ADDENDUM NO. 3

Project Name: Building Renovation for Haverford Township Free Library
Project No.: 7010.03-22
Date of Issue: October 10, 2023
Notice 1: Attach this addendum to the Project Manual for this project. It modifies and becomes part of the Bidding Documents. Work or material not specifically mentioned herein is to be as described in the main body of the Project Manual, and as shown on the drawings.

Sheet Number:
DMPE1.3

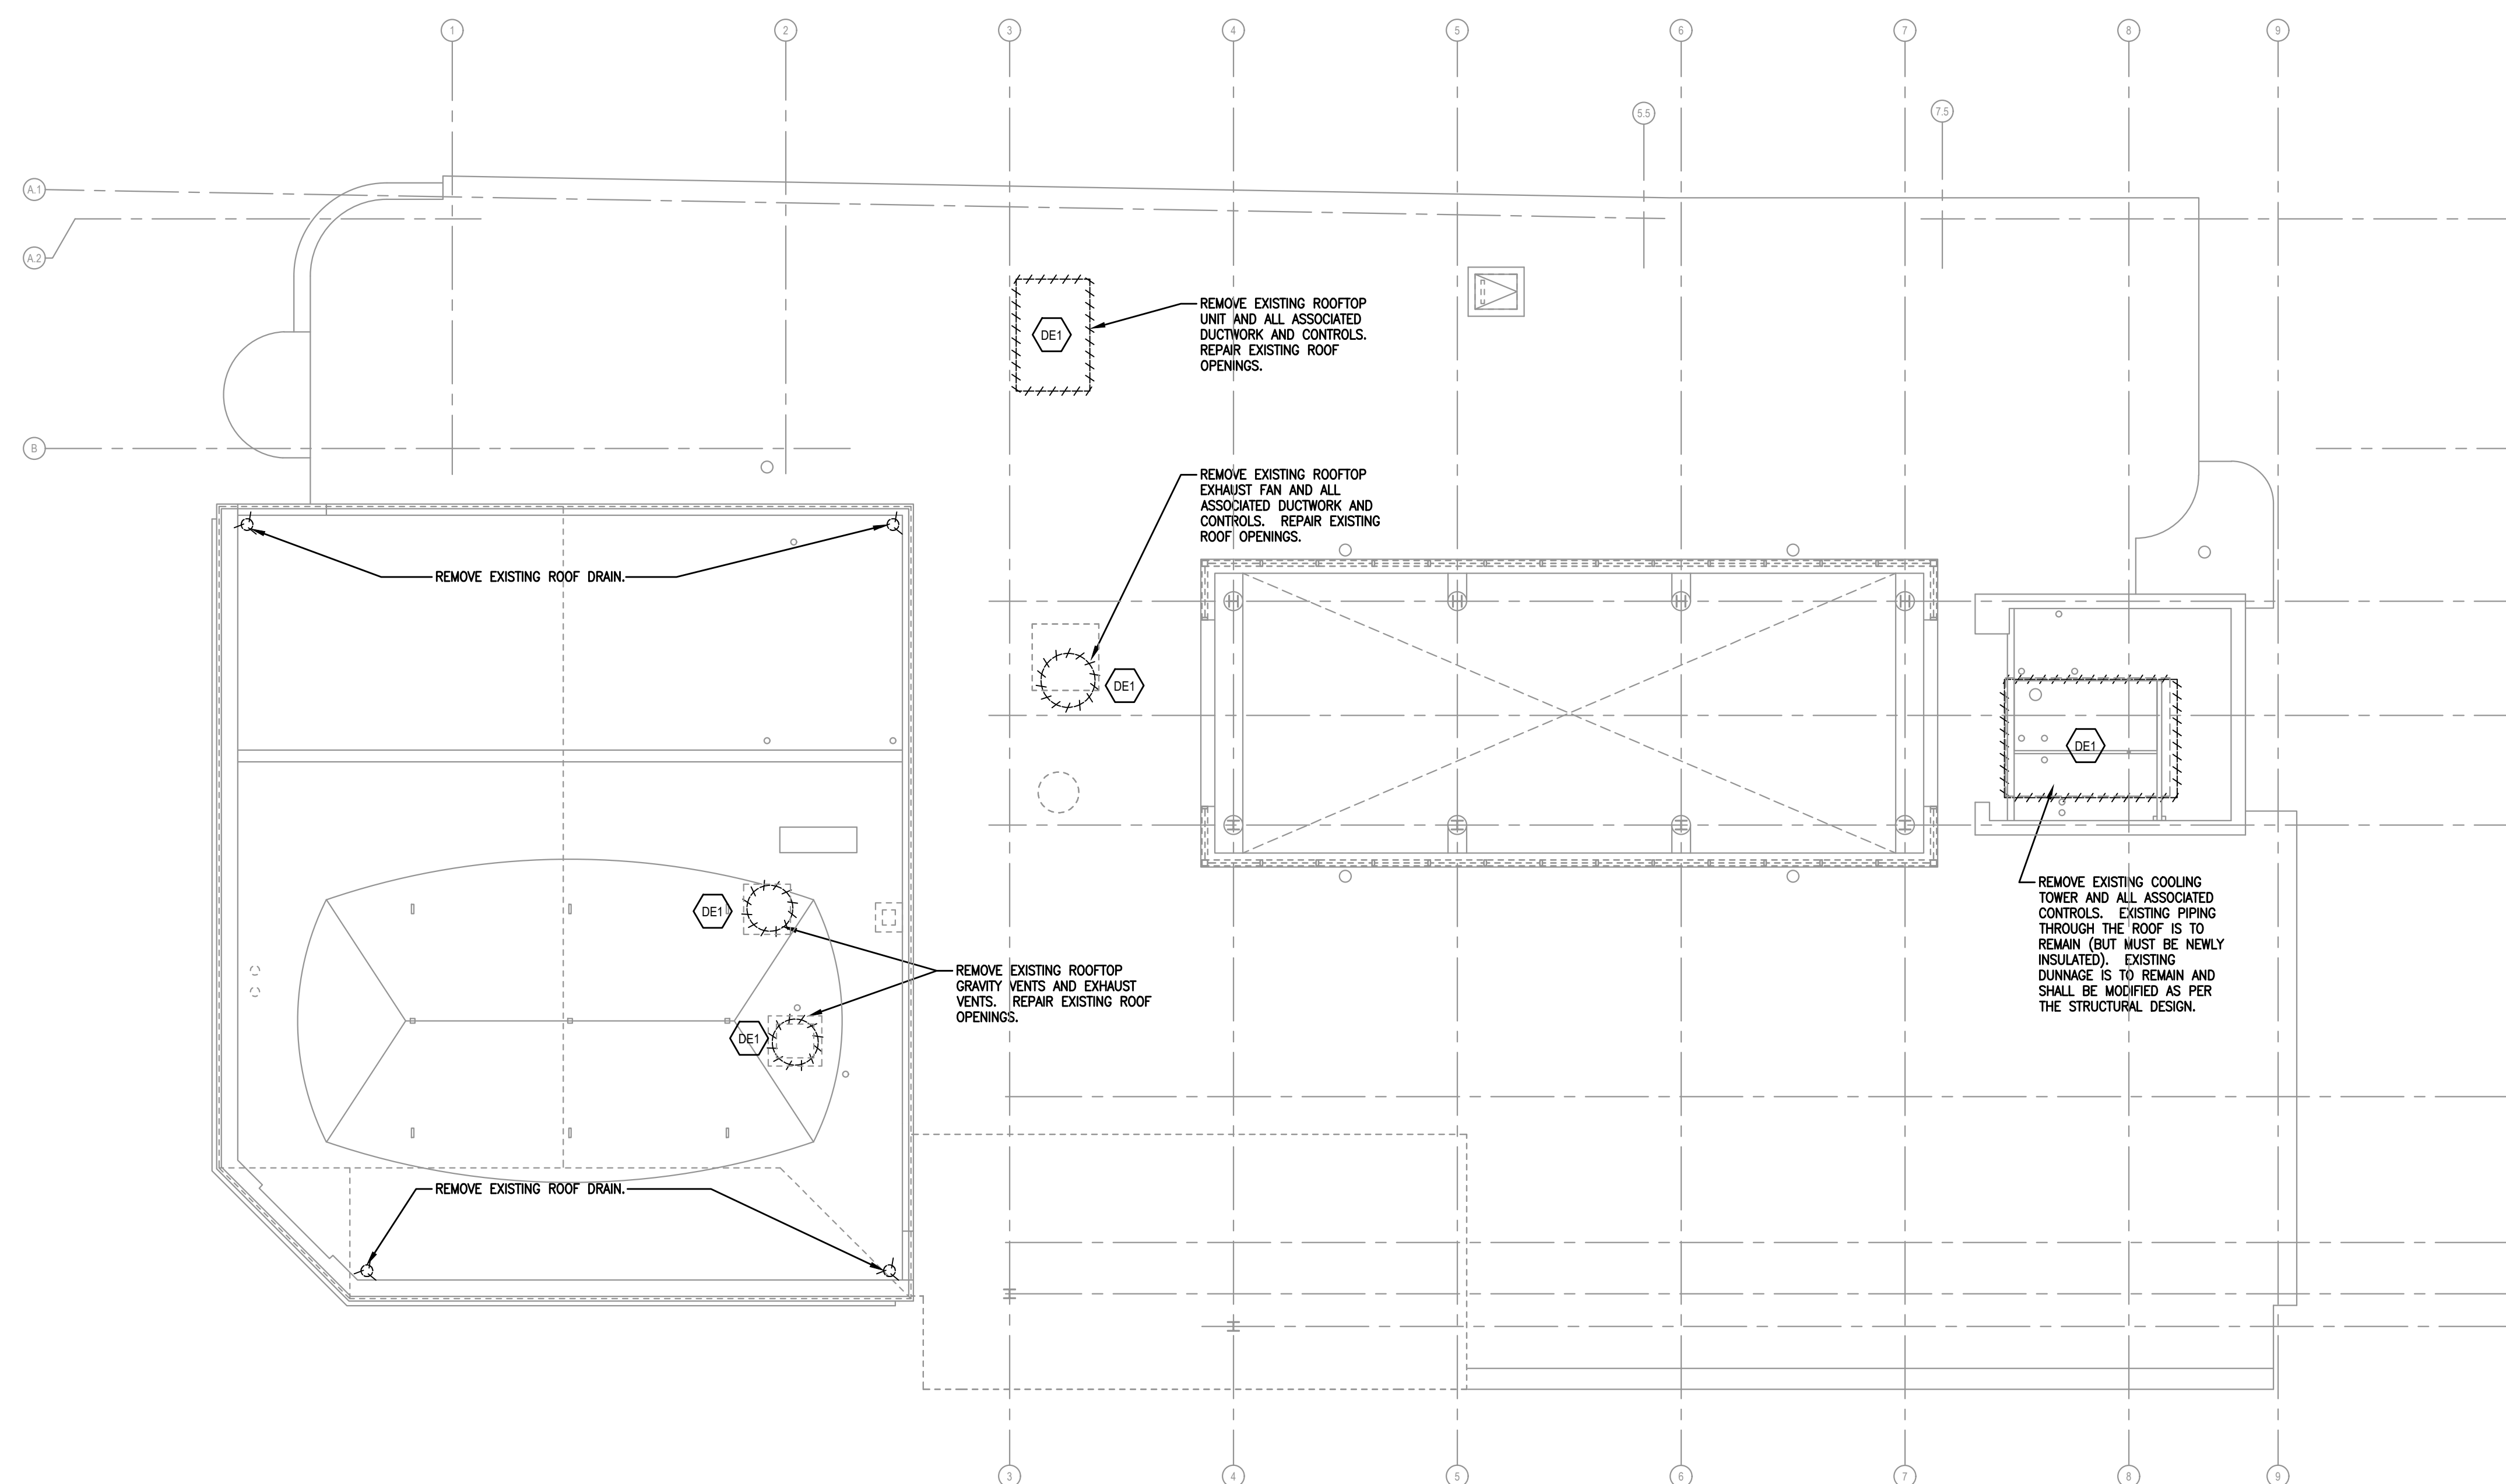
10. On Sheet **DMPE1.3**, revise Mechanical Demolition Notes, as indicated. The revised sheet is attached as part of this addendum.
11. On Sheet **M1.2**, revise references to Rad-2 in Meeting Room (Room 220). The revised sheet

HOT WATER SEQUENCE NOTES:

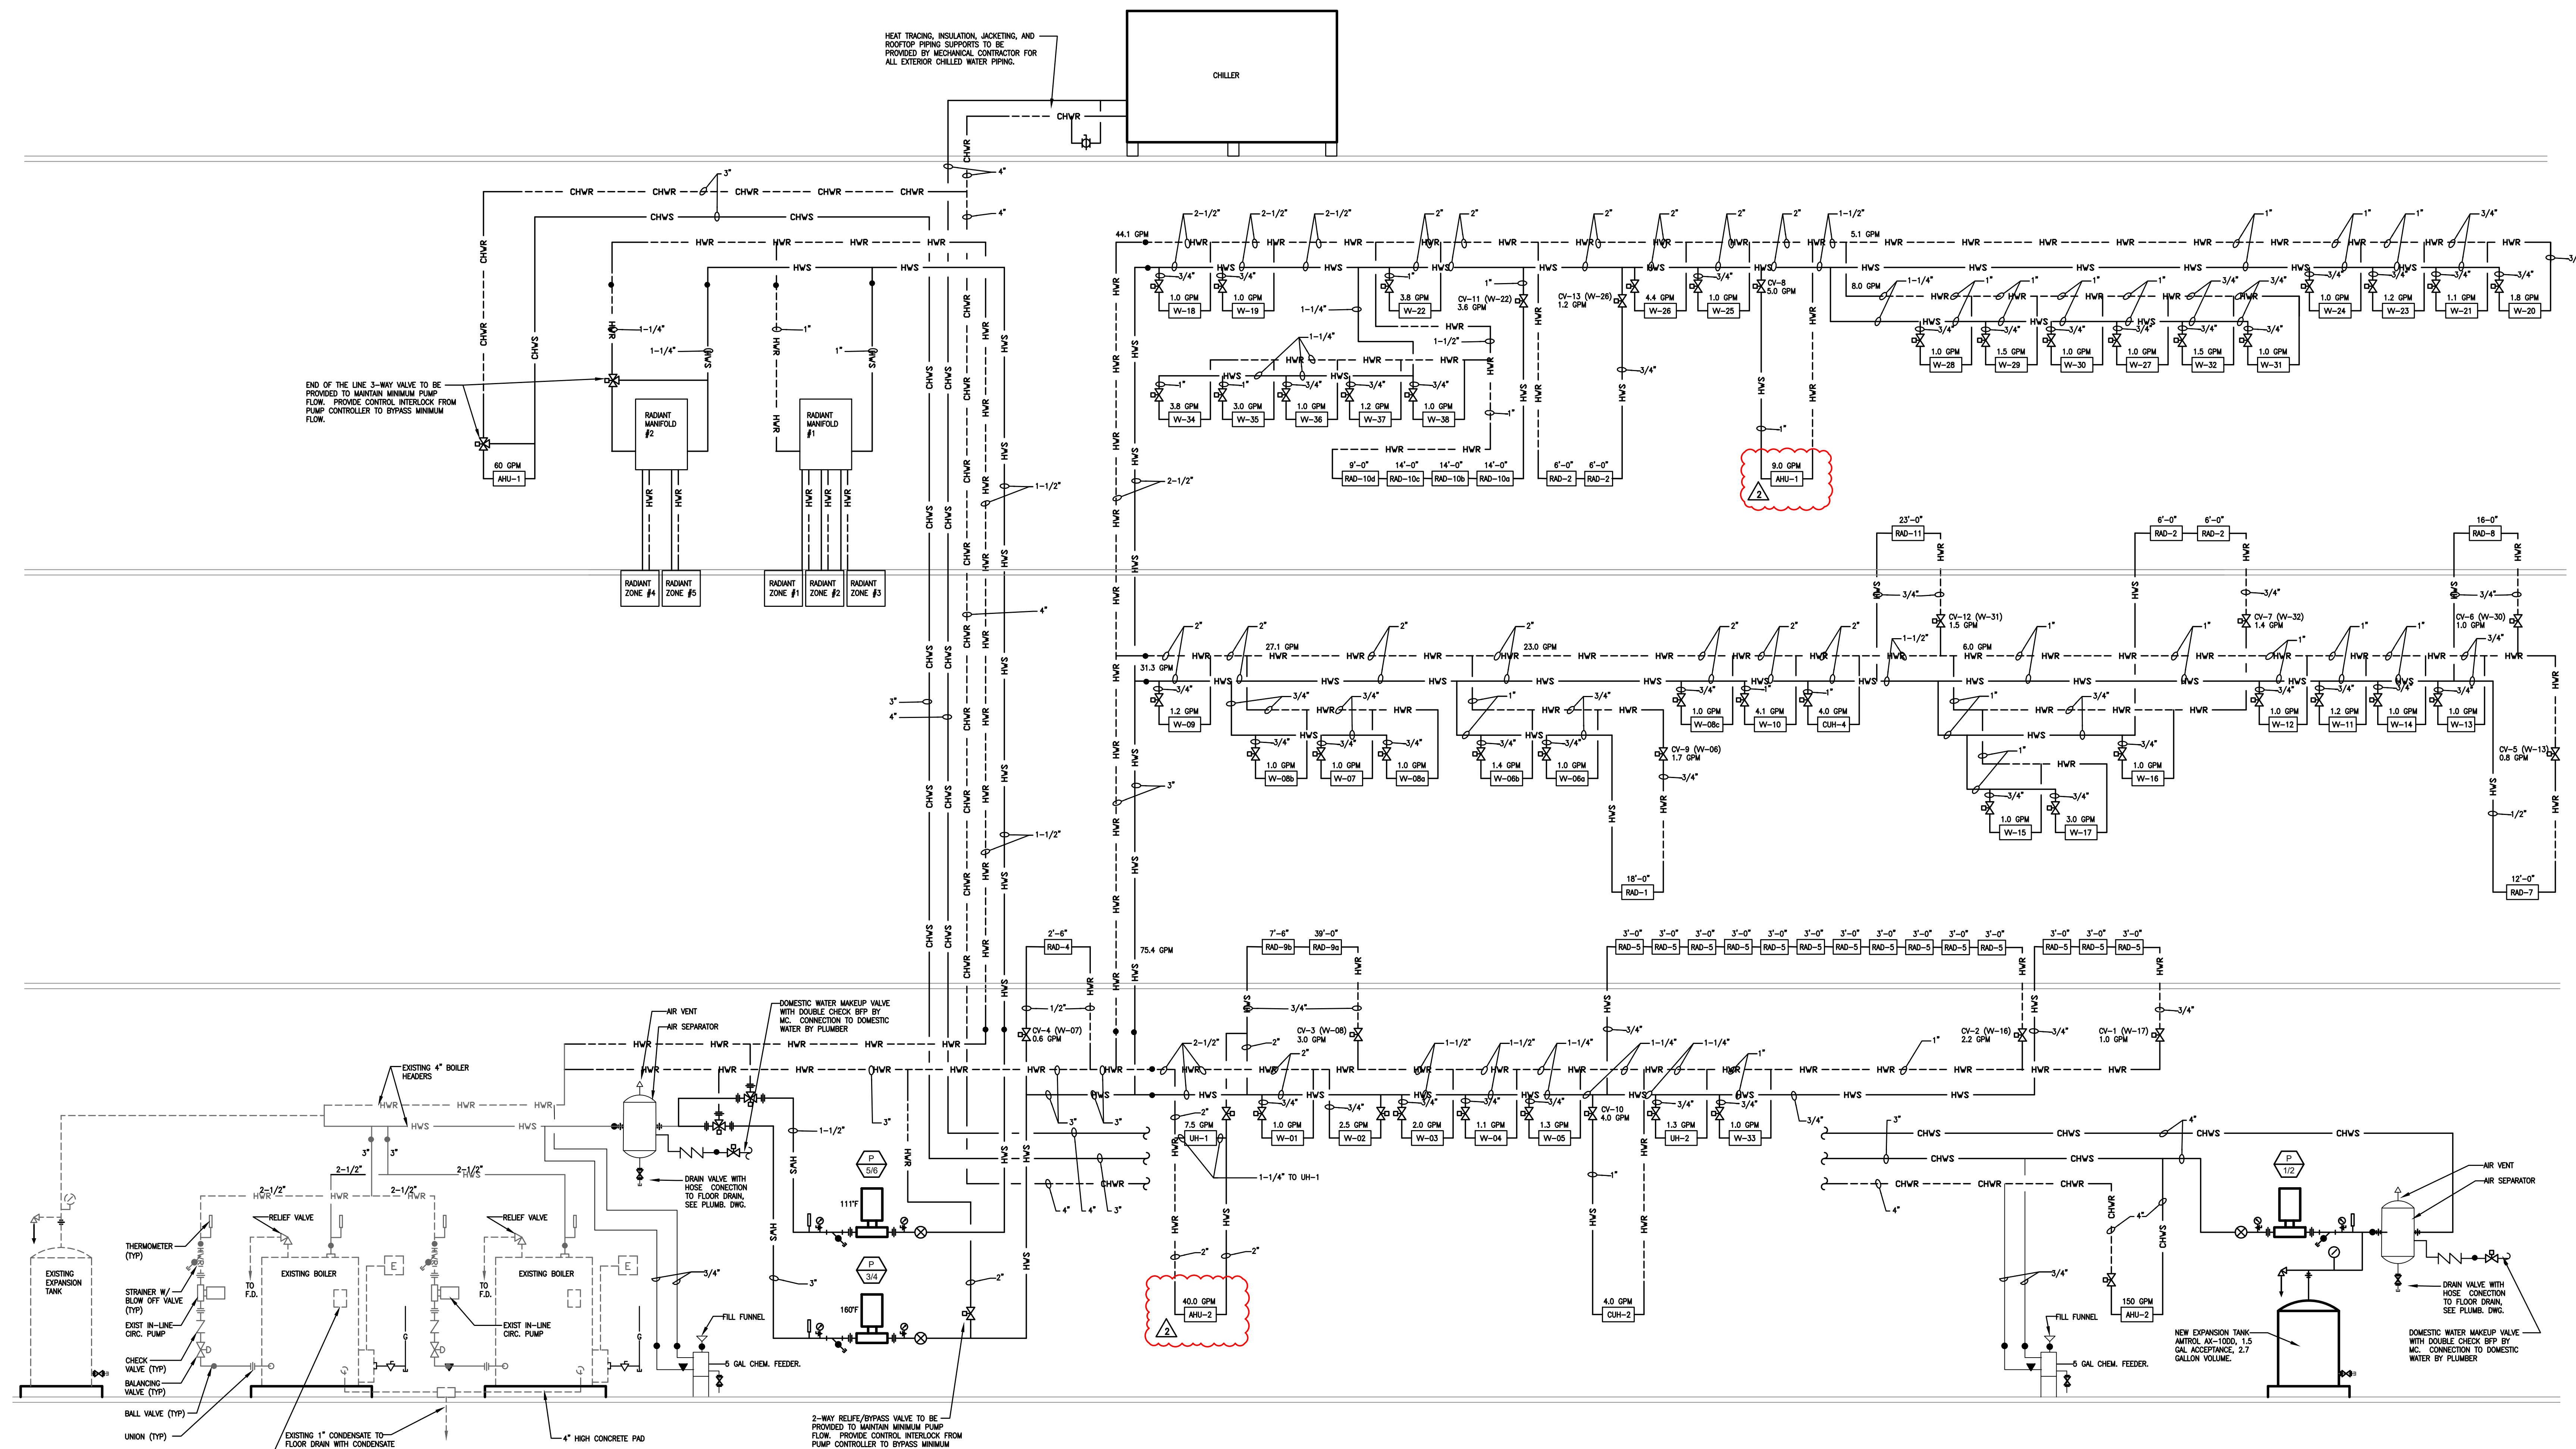
13. On Sheet **M2.2**, revise Air Device Schedule as indicated. The revised sheet is attached as part of this addendum.
 14. On Sheet **M2.3**, revise Hot & Chilled Water Piping Diagram and add Hot Water Sequence Notes as indicated. The revised sheet is attached as part of this addendum.

FIRE SERVICE DETAIL

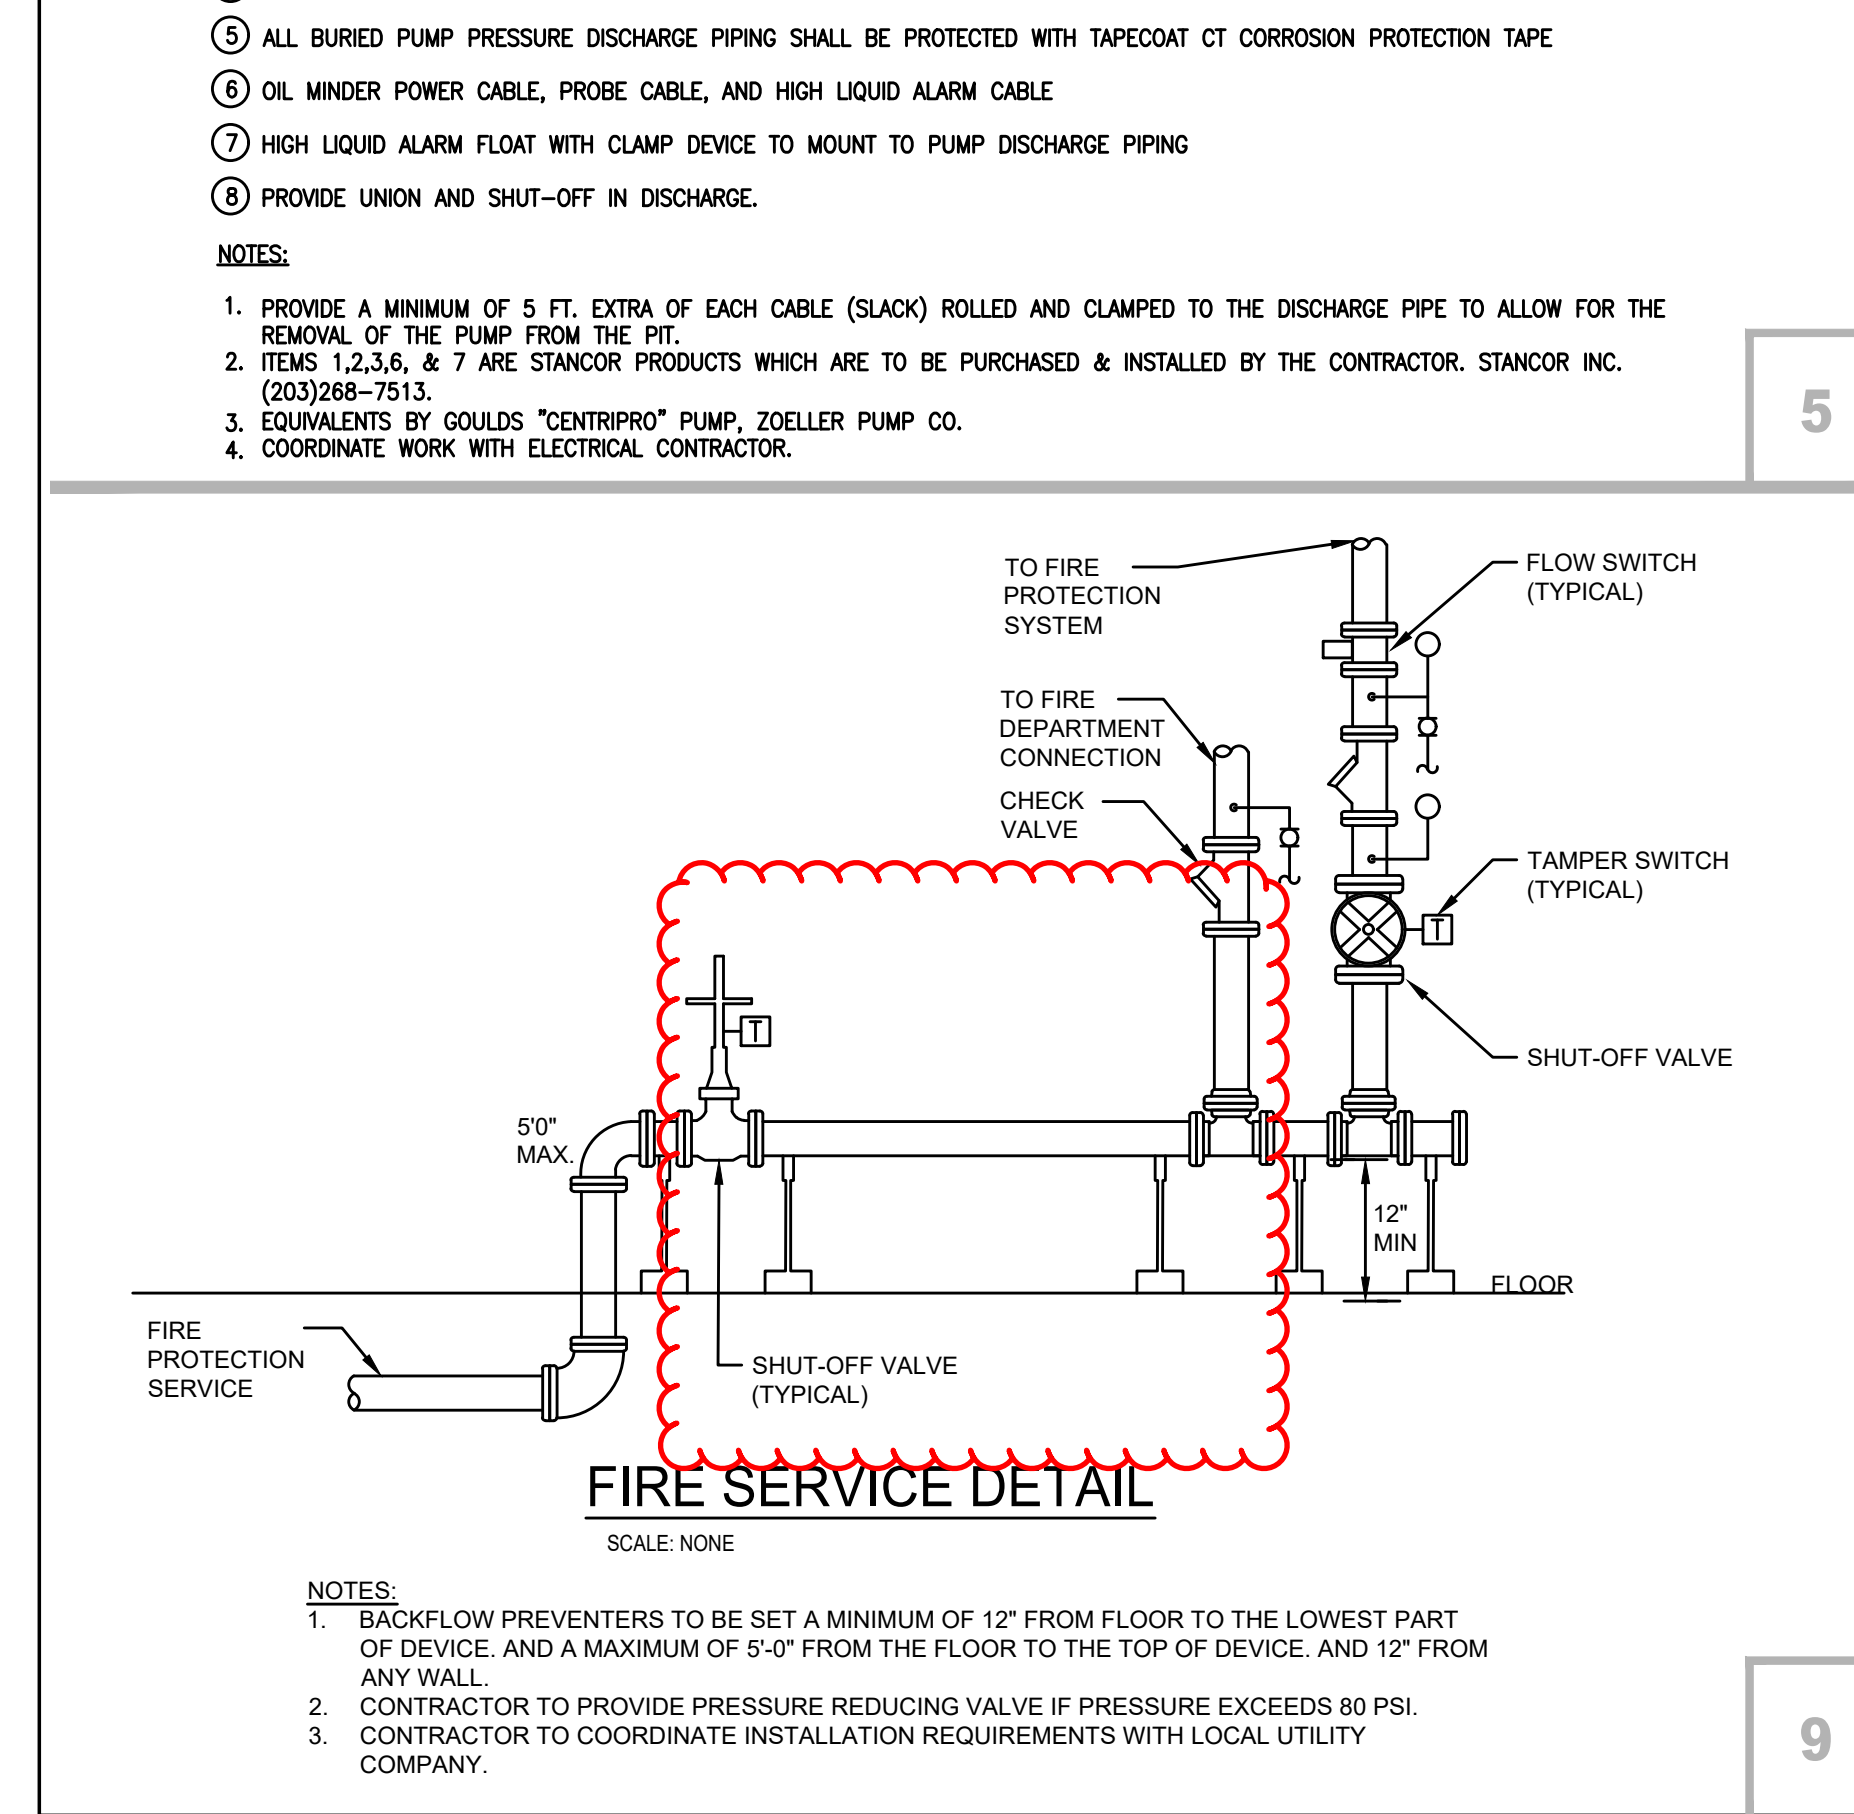
18. On Sheet **P2.0**, at Fire Service Detail 9, delete backflow preventer as indicated. A back flow preventer is provided in the meter pit provided by the GC. The revised sheet is attached as part of this addendum.
